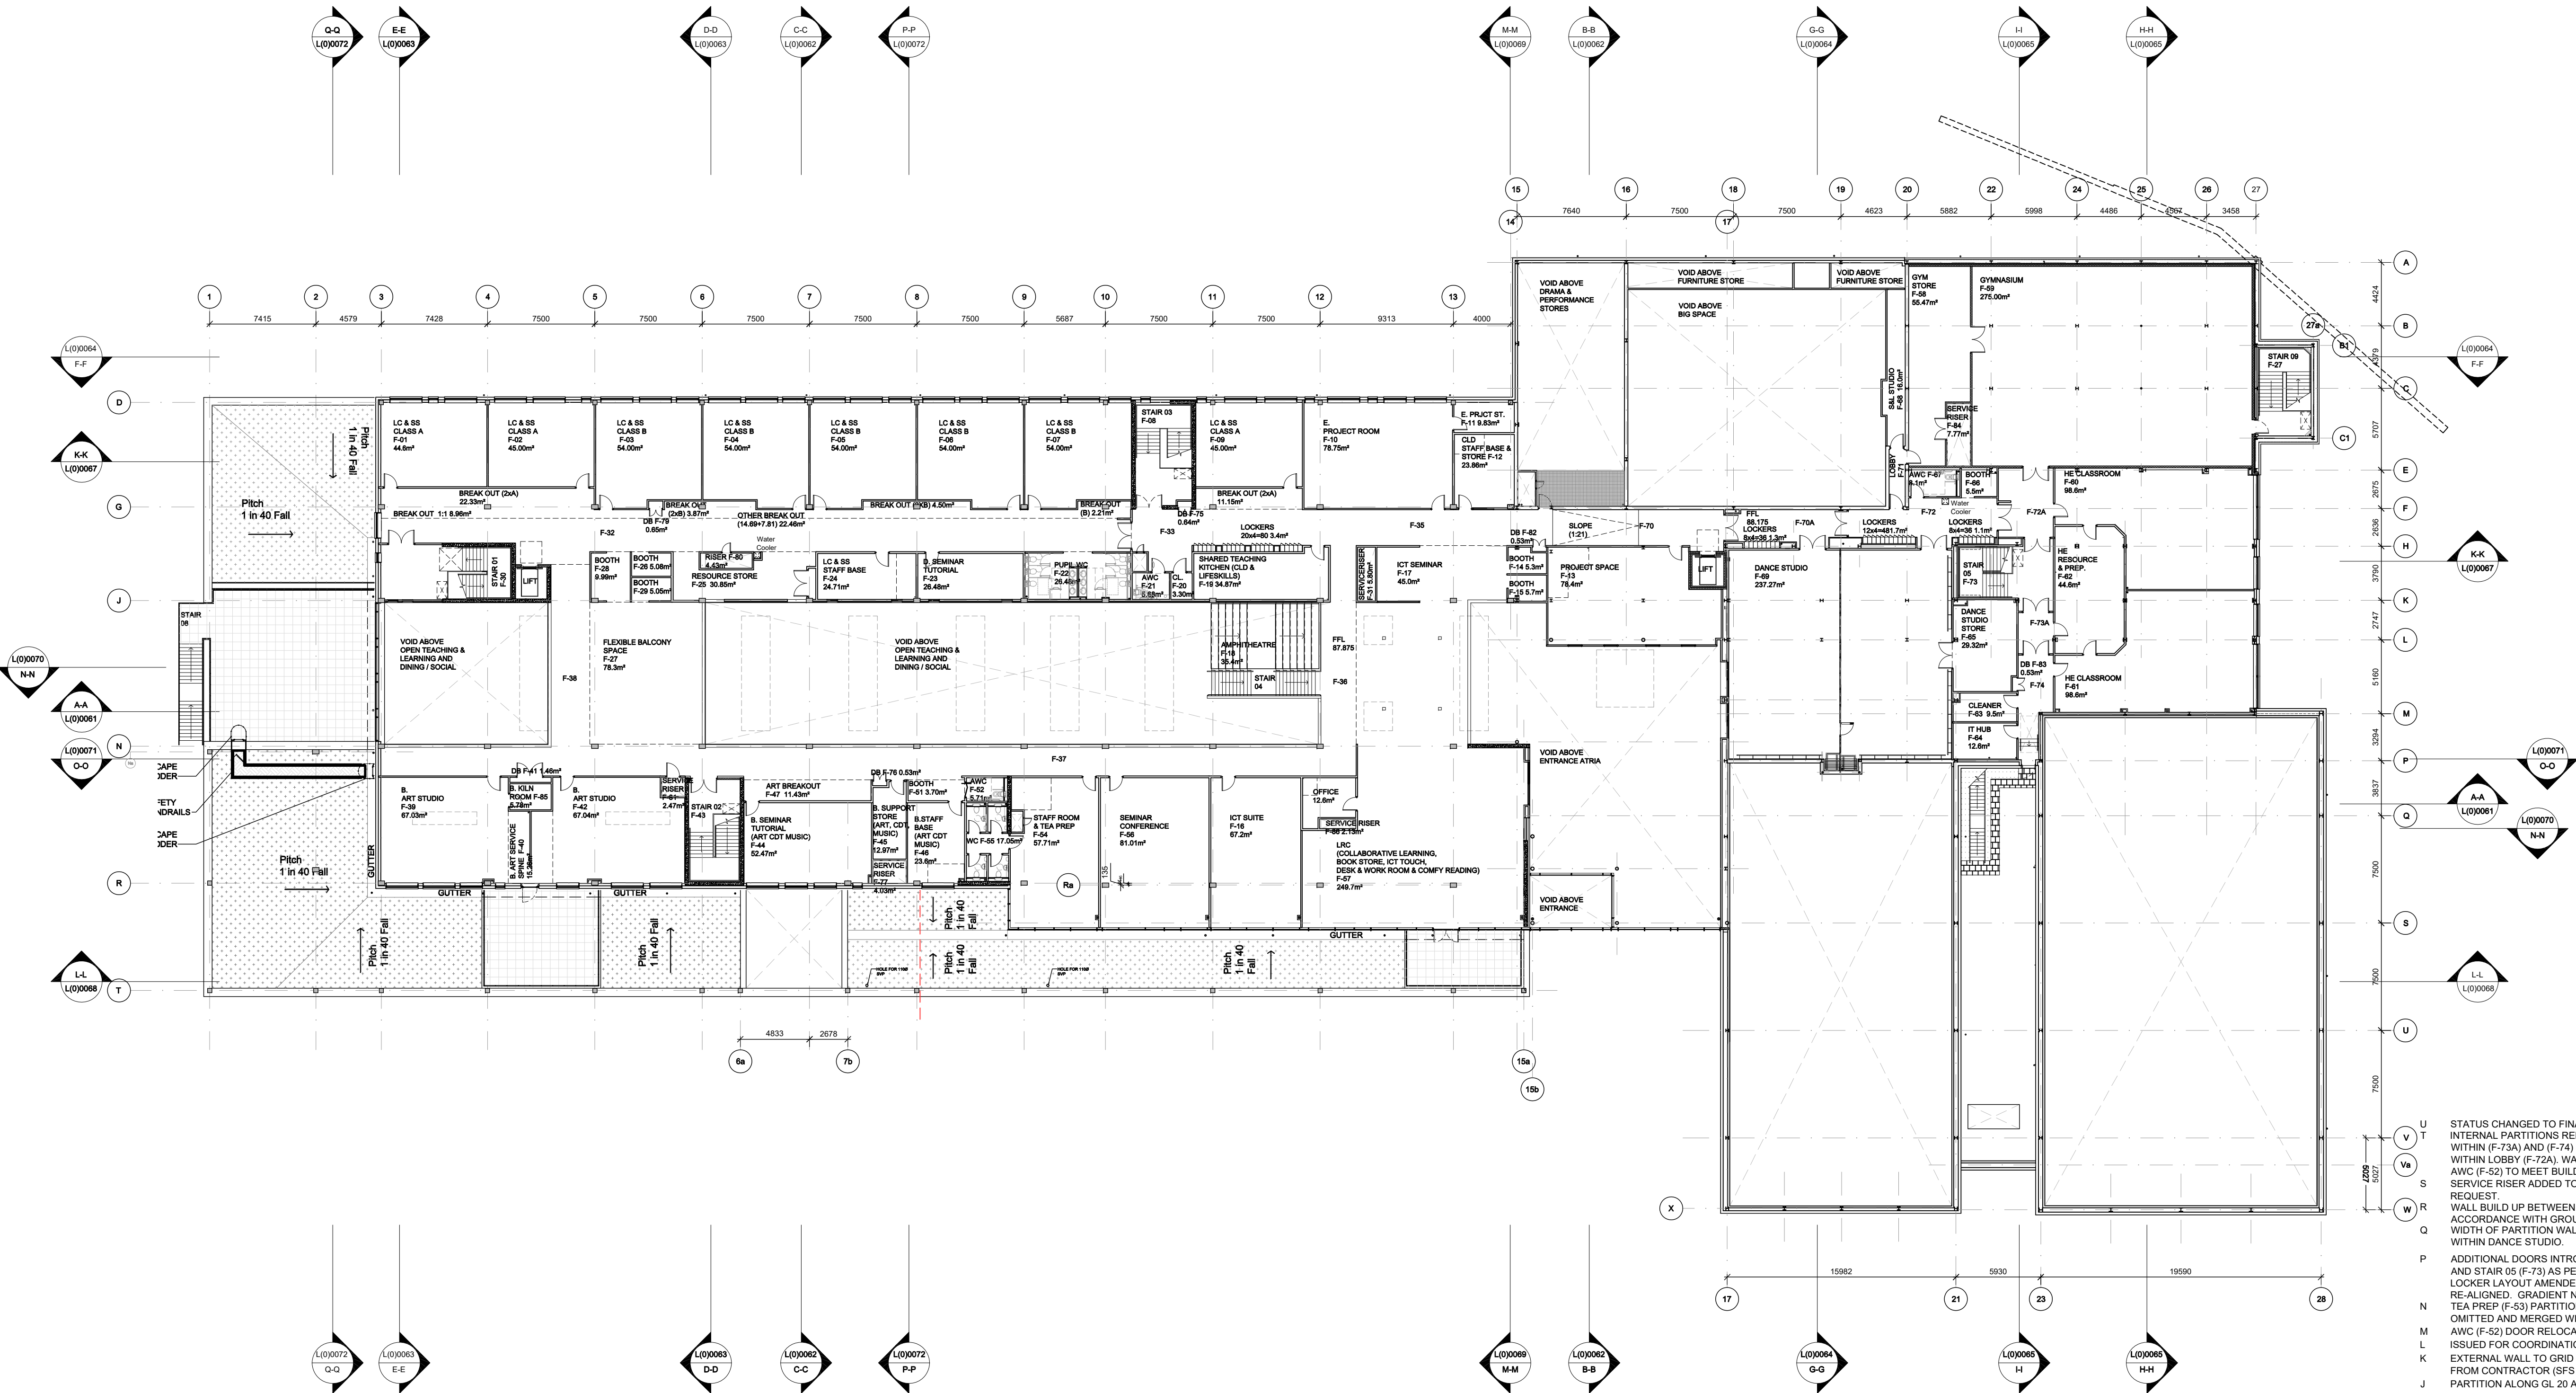
STATUS CHANGED TO FINAL CONSTRUCTION.	20.10.15	GJB	RD
INTERNAL PARTITIONS RELOCATED TO INCREASE CORRIDOR WIDTH WITHIN (F-73A) AND (F-74) TO SUIT SITE CONDITIONS. WALL NIB ADDED WITHIN LOBBY (F-72A). WALL NIB ADDED AND DOOR MIRRORED WITHIN AWC (F-52) TO MEET BUILDING CONTROL REQUIREMENTS.	30.06.15	GJB	LF
SERVICE RISER ADDED TO RESOURCE STORE (F-25) AS PER M&E REQUEST.	02.06.15	GJB	LF
WALL BUILD UP BETWEEN LRC (F-) AND ENTRANCE ATRIUM UPDATED IN ACCORDANCE WITH GROUND FLOOR PLAN.	26.05.15	LF	GJB
WIDTH OF PARTITION WALLS AMENDED AROUND STORAGE PARTITION WITHIN DANCE STUDIO.	15.05.15	LF	GJB
ADDITIONAL DOORS INTRODUCED TO CIRCULATION (F-72), LOBBY (72-A) AND STAIR 05 (F-73) AS PER BUILDING CONTROL REQUIREMENT: LOCKER LAYOUT AMENDED TO SUIT. DOORS TO DANCE STUDIO RE-ALIGNED. GRADIENT NOTE ADDED TO SLOPE.	29.04.15	LF	GJB
TEA PREP (F-53) PARTITIONS AND DOOR REMOVED. TEA PREP (F-53) OMITTED AND MERGED WITH STAFF ROOM (F-54).	10.04.15	LF	GJB

AWC (F-52) DOOR RELOCATED TO SUIT TECHNICAL STANDARDS.	02.04.15	GJB	CQ
L ISSUED FOR COORDINATION	16.02.15	GJB	
EXTERNAL WALL TO GRID LINE 3 AMENDED FOLLOWING INSTRUCTION FROM CONTRACTOR (SFS REDUCED FROM 200mm TO 150mm).	27.01.15	GJB	
PARTITION ALONG GL 20 A-F ALIGNED WITH COLUMNS:	02.12.14	AW	GJB
STAIR 09 RELOCATED TO SUIT EXTERNAL RETAINING WALL: BOOTH F-66 AND AWC F-67 MOVED TO ALLOW BRACING IN THIS AREA: STAIR 03 DOOR AMENDED: SERVER RISER F-86 ADDED AS M+E ENGINEER'S REQUESTED. EXTERNAL WALL ON GRIDLINE N MOVED TO SUIT SLAB EDGE LOCATION.	07.11.14	AA	GJB
STAIR 05 RELOCATED TO RESOLVE STRUCTURAL CLASH: LOCKERS AMENDED & REPOSITIONED FOLLOWING CONFIRMATION OF SIZE FROM F&E SUPPLIER. STRUCTURAL GRID UPDATED TO ACCORD WITH STRUCTURAL ENGINEER'S INFORMATION (GRID LINES 19, E & Q RELOCATED); COLUMN LAYOUT UPDATED TO ACCORD WITH STRUCTURAL ENGINEER'S LAYOUT.	03.10.14	AA	GJB
